CARMEL APARTMENTS

INTERSECTION SIGHT DISTANCE PLAN

**Re: CARMEL APARTMENTS A**  
**7310 Carmel Ave. NE**  
**Traffic Circulation Layout**  
Architect's Stamp 03-03-2022(C19-069A)

Based upon the information provided in your submittal received 04-13-2022, the above referenced plan cannot be approved for Building Permit until the following comments are addressed:

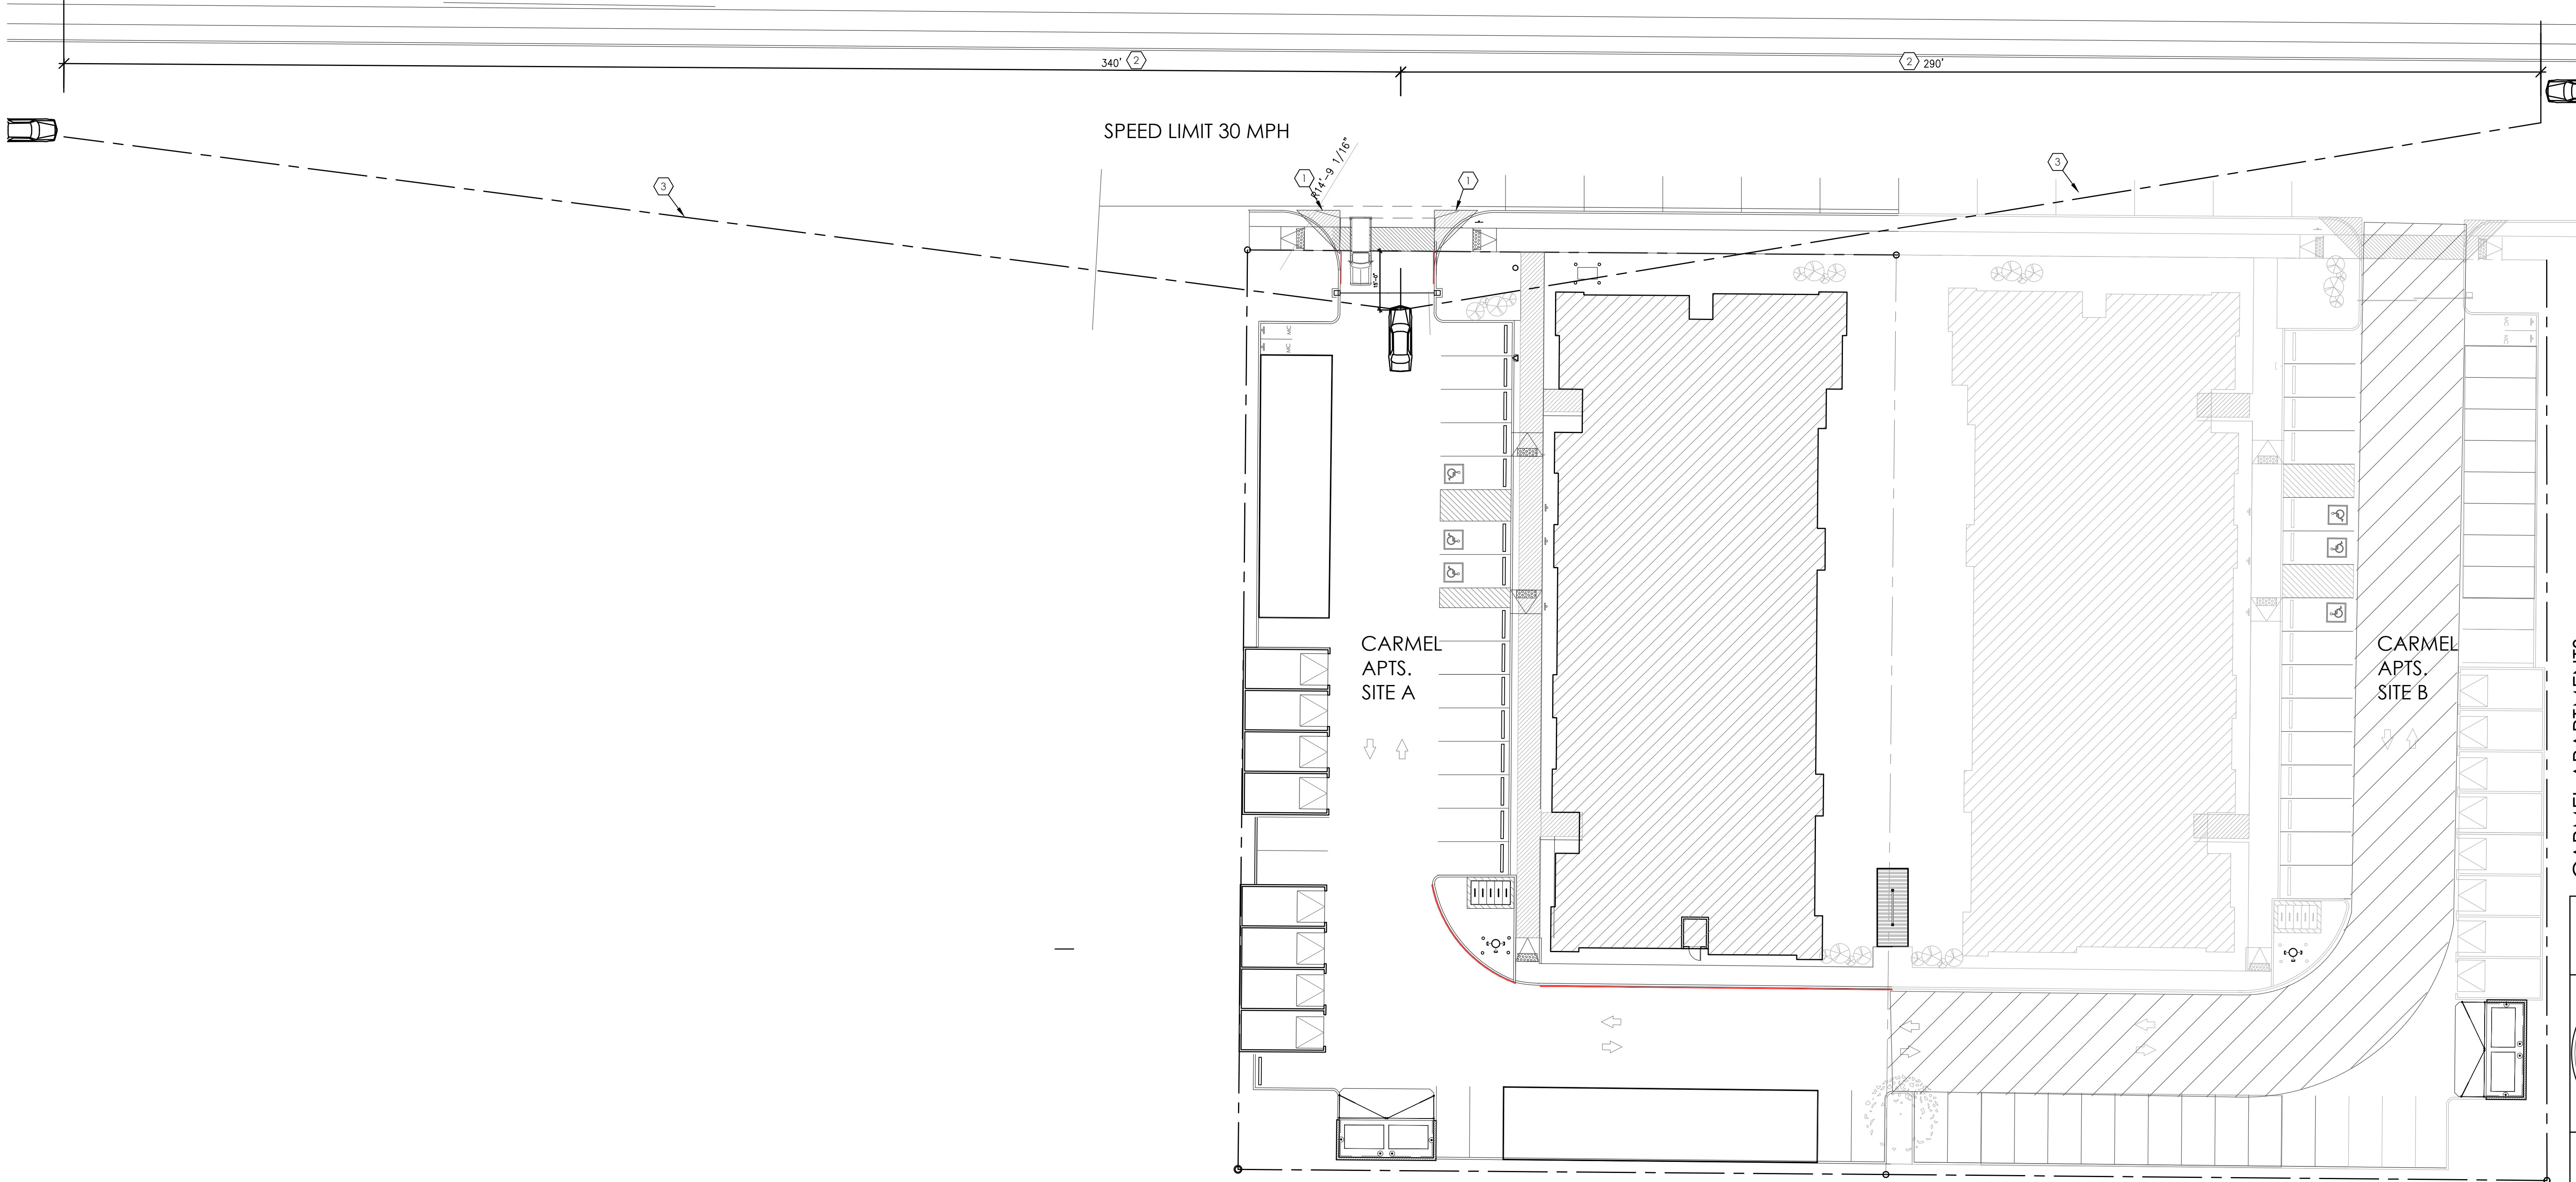
- From above, pick which one will apply to this concern of Carmel's missing roadway portion. **PLEASE SEE ATTACHED PLAT**
- It appears that you are proposing onstreet parking. Please coordinate with Traffic Operations on the striping or remove striping. You will need a **clear site line exhibit** since onstreet parking is being proposed and might possibly block stopping site distance.

OVERALL SITE PLAN - CARMEL APARTMENTS

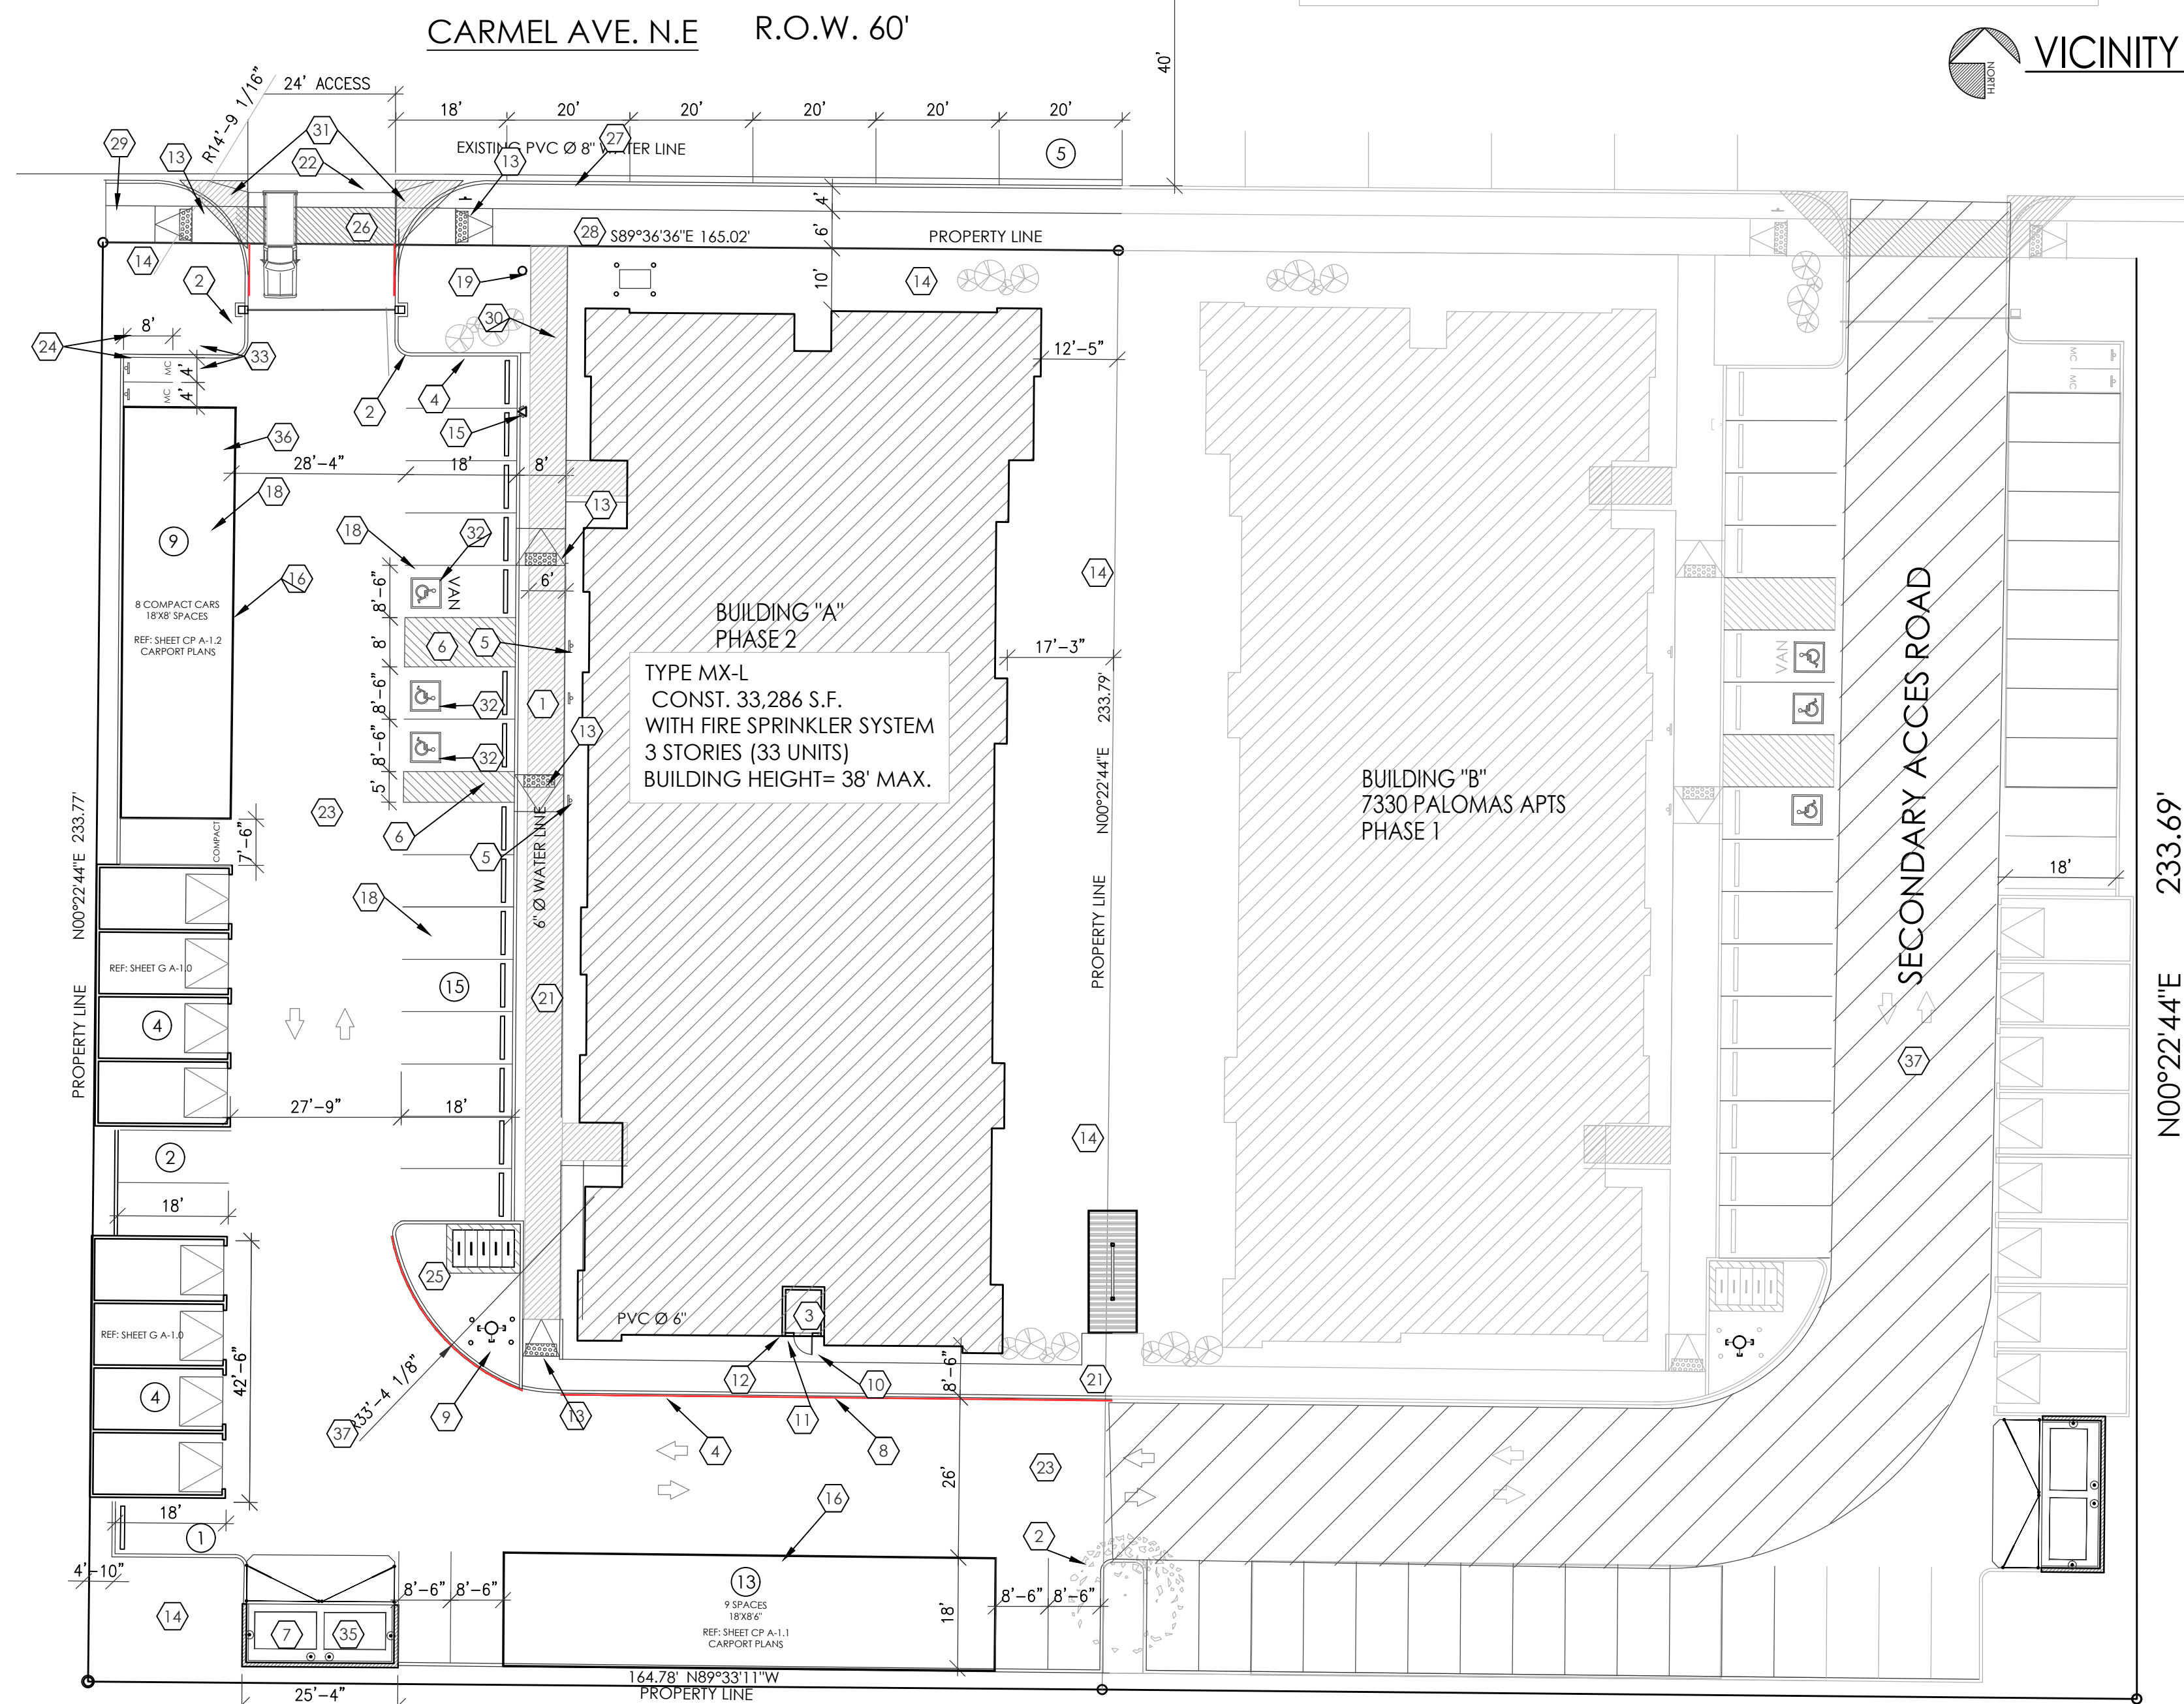
- **Keyed Note 22:** Change notation from drivepad to driveway and show the 6 ft valley gutter as part of the entrance drawing. **SEE UPDATED KEY NOTE**

- **Keyed Note 26:** Proposed cross pathway striping will need detail for striping. **SEE DETAIL A9/AS-2.0**
- **Keyed Note 28:** Provide a tie-in grade of 5:1 back to existing surface elevation at end of sidewalk. **SEE UPDATED KEY NOTE**

- **Keyed Note 29:** Reference COA std dwg 2430 for sidewalk detail and provide a tie-in grade of 5:1 back to existing surface elevation at end of sidewalk. **SEE UPDATED KEY NOTE**

- **Keyed Note 34:** Nope, remove this note. **KEY NOTE REMOVED**
- 3. An secondary emergency access will need to be provided as part of this proposed development and a temporary paved connection back to Carmel Ave will be needed as part of the TCL requirement. **SEE SECONDARY ROAD ON SITE PLAN**

- 4. **Keyed Note 1:** Reference A8/AS-2.0 instead of A10. **UPDATED**
- 5. **Keyed Note 13:** Reference either detail A8 or A10 on sheet AS-2.0 for proposed ramp.

- 10. **Detail A10:** 50:1 and 12:1 should have the word max. after each text. **DETAIL UPDATED**
- 11. **ADA Parking Access Aisle dimensions on site lan}**: You specify 8'-6" on layout but on detail you call out 8'-0". Please address this concern. **SITE PLAN DIMENSION UPDATED**

- 12. **Proposed Compact parking stalls:** Provide stall lengths for compact parking stalls. **see updated site plan**
- 13. You have a hatch area/segment of pavement around the drive aisle located at the corner back of the proposed building and no legend to define this hatching. Please provide some type of note to define this hatching. **See updated site plan**

- 14. Identify the right of way width medians, curb cuts, and **street width on** Carmel Ave. Clarify proposed property lines since an approved Plan was not provided. **SEE ATTACHED PLAT AND R.O.W. ON SITE PLAN**

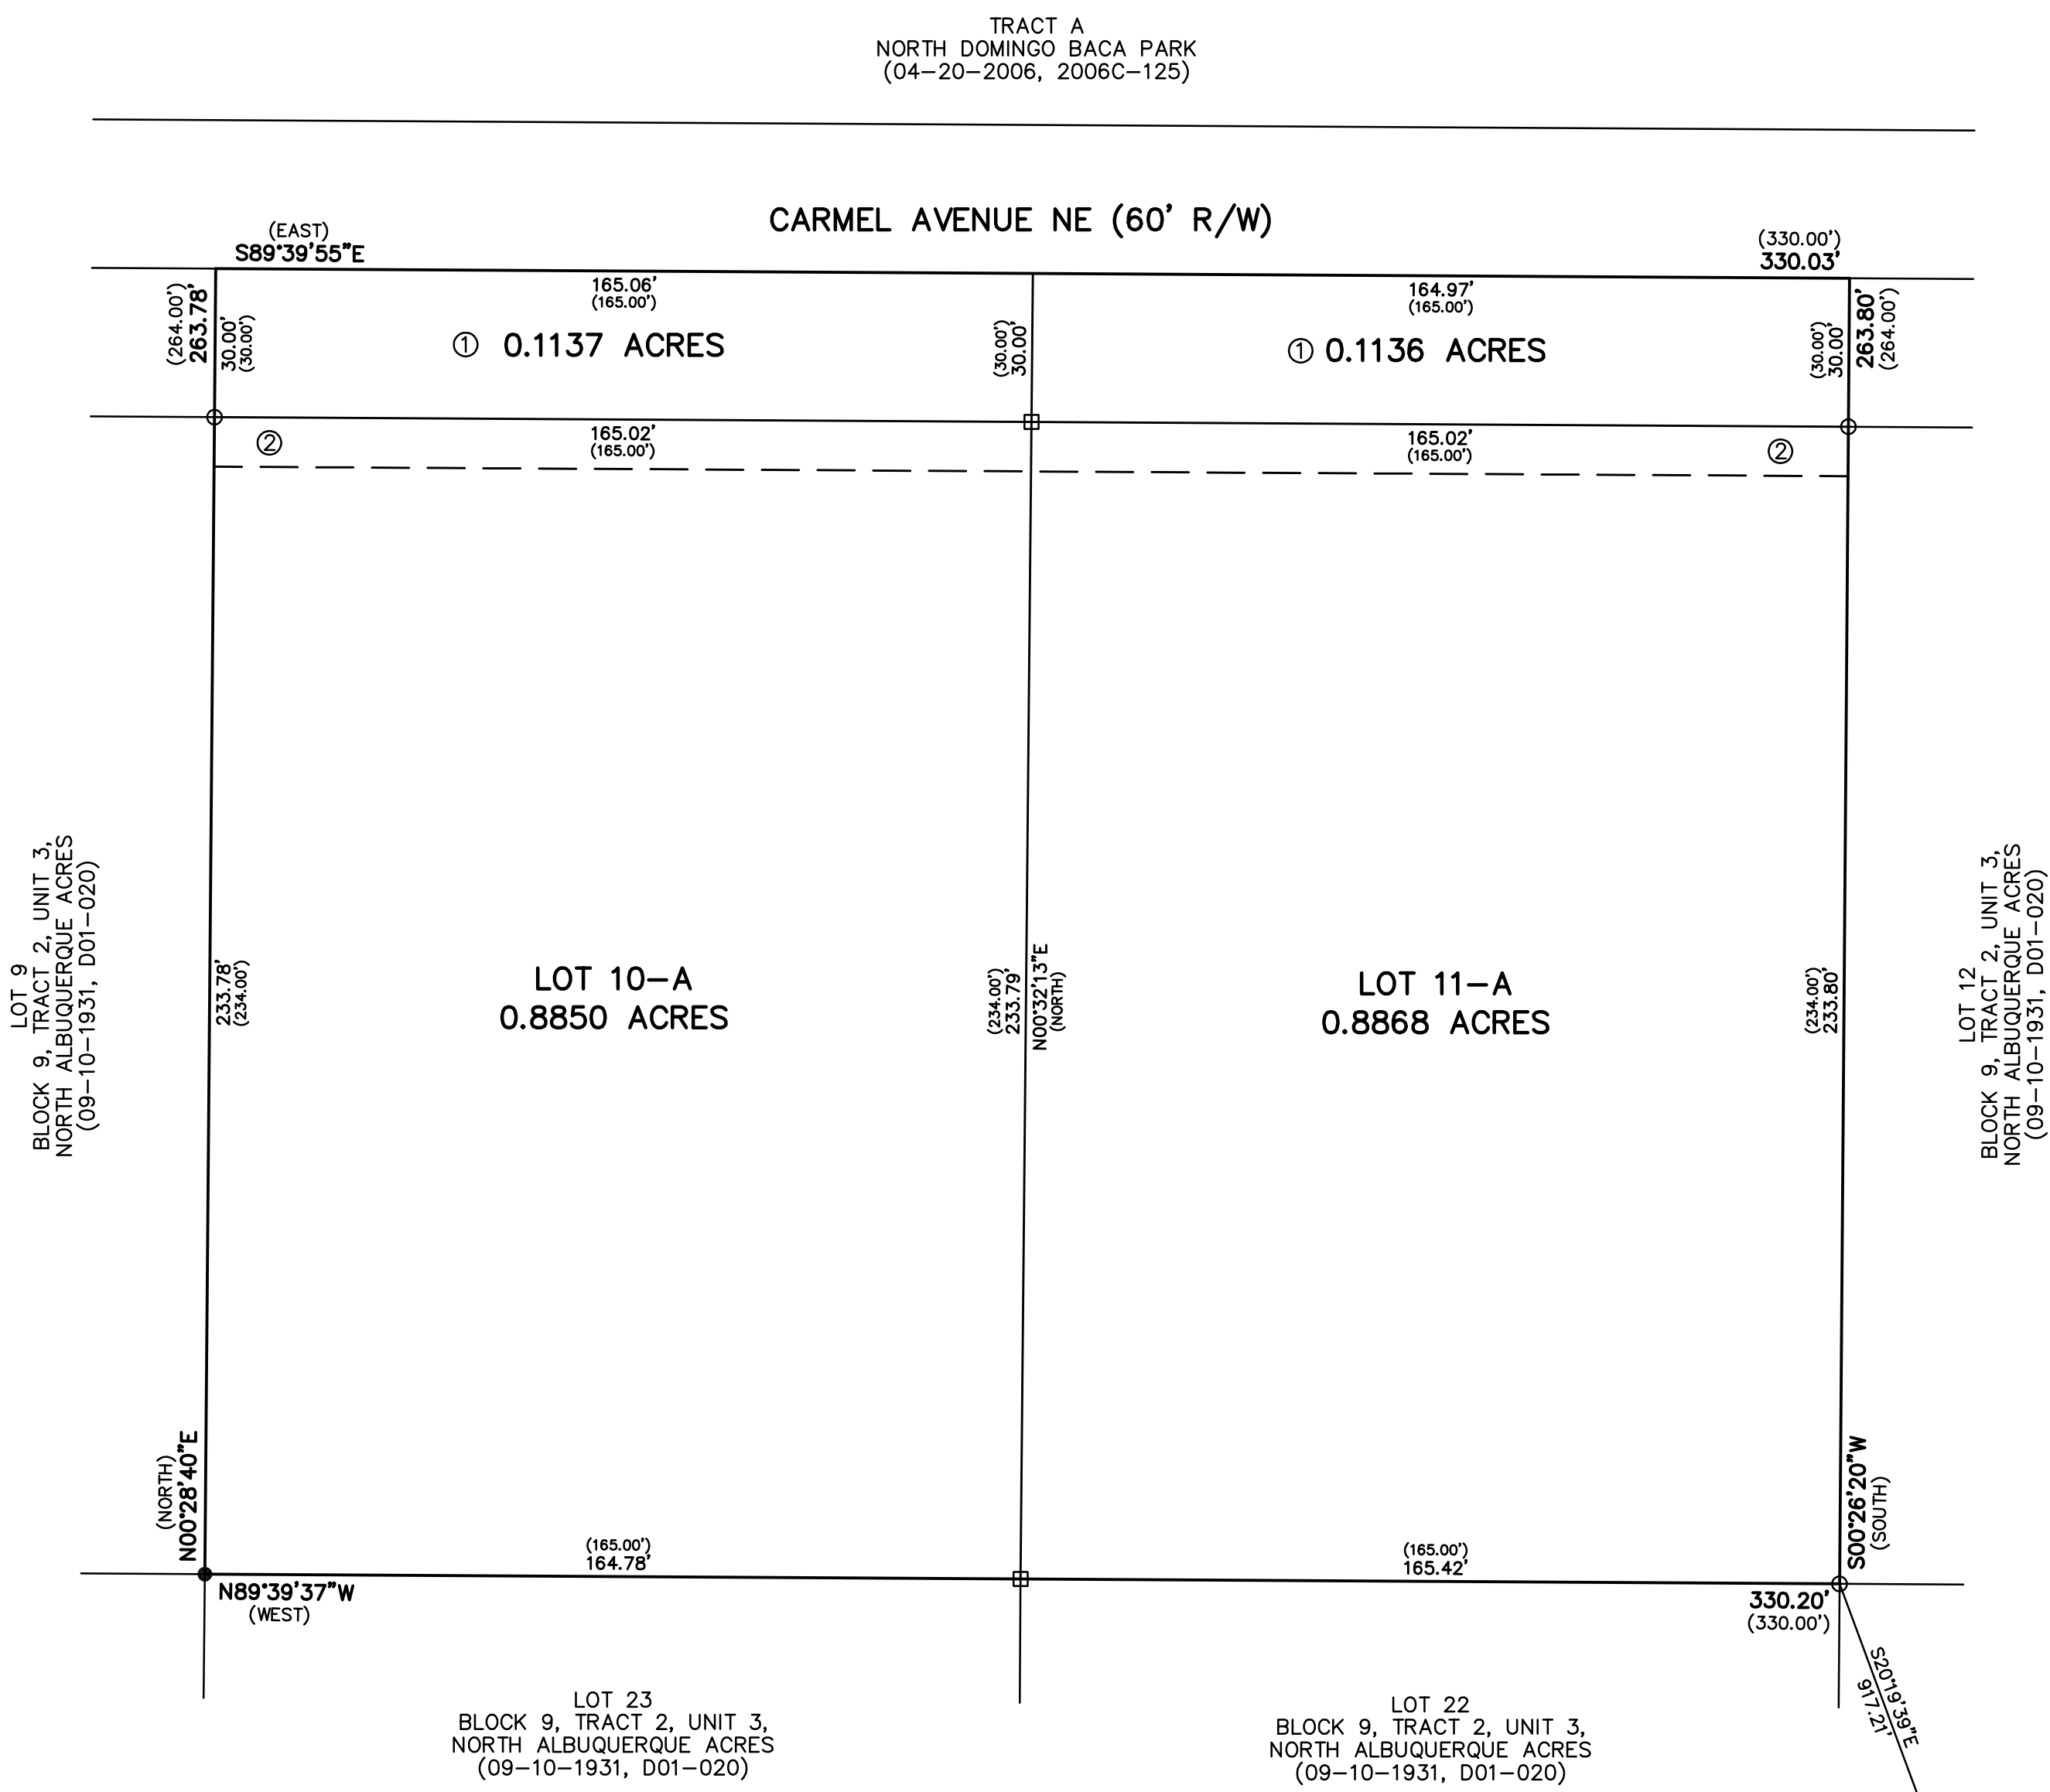
- How was the curblin/setback requirements determined without an approved Plat (Not provided)?
- An approved Plat will need to be provided.
- What is the status on the missing portion of Carmel Ave Roadway Infrastructure? You will need to provide an infrastructure list and/or financial guarantee (DRB action required).

You will need an approved Plat (ORB action required).

- 16. **SEE ATTACHED PLAT AND R.O.W. ON SITE PLAN**
